## BCA CONCEPT REVIEW

<b>Date</b>	3 April 2025
<b>Prepared by</b>	Brett Fennell
<b>BUILDSURV Ref</b>	9563
<b>Job Name</b>	100 Rundle Mall – Adelaide Central Plaza Redevelopment
<b>Proposed works</b>	Alterations for new 30-storey commercial development
<b>Client</b>	Cameron Thompson (Podia)

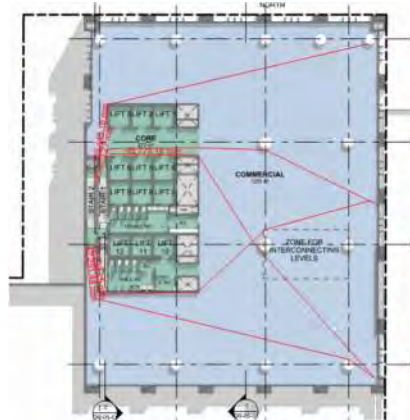
- The building is also exposed to fire source features which includes the eastern and western boundaries. External walls within 3 metres of the boundary (or 6m to adjacent boundary across a street) are required to be fire resisting which requires that any openings in the walls are also required to be fire resistant (need to determine the width of Charles Street)

- The eastern elevation currently shows openings to the office tower which are not permitted unless they are protected using window drenchers. If drenchers are used then they are only permitted to be used for 1/3 of the area of the external wall of the storey or, a **Performance Solution** sought to allow further protected openings to this elevation.

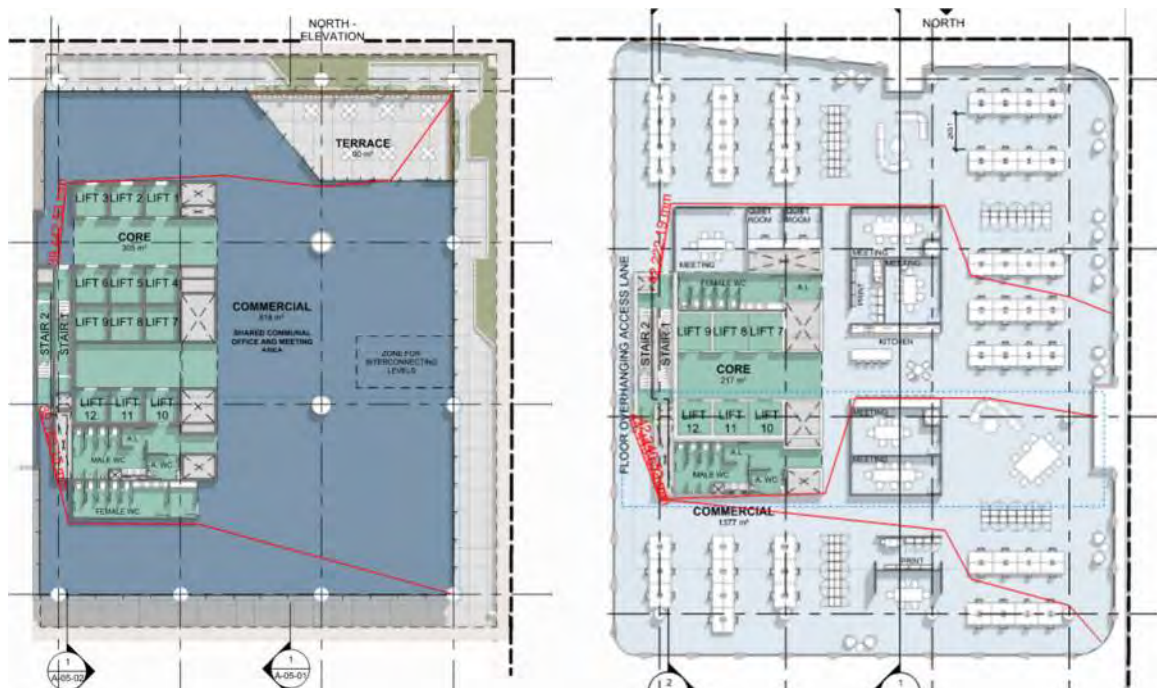
- It should also be noted that consideration needs to be made with regards to the future fitout of the tenancy in that the construction of partition walls and lobby areas may mean that the egress paths are extended to beyond 40m (see below plan). Its suggested this is discussed with a BCA Consultant and Fire Engineer as part of the design development process (including the egress paths more than 60 m apart)
